Product Change Notice

Issue Date: 26-October-2021

IC Change - New IC has wider metal trace that improve robustness. This new IC adds to an alternate source for ACPL-P454 and ACPL-W454 business continuity plan

Appendix I: IC change details

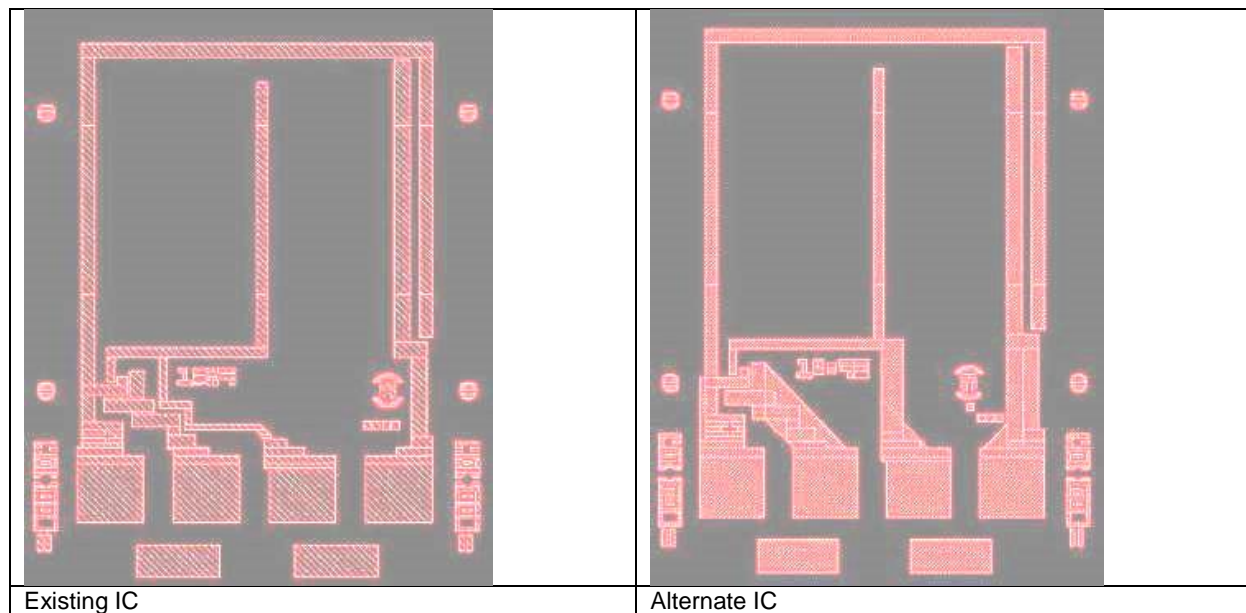
Same IC with wider metal trace. Please refers to Appendix I.

The alternate IC is same as the existing IC, with wider metal trace for improved robustness.
No performance change from existing IC.
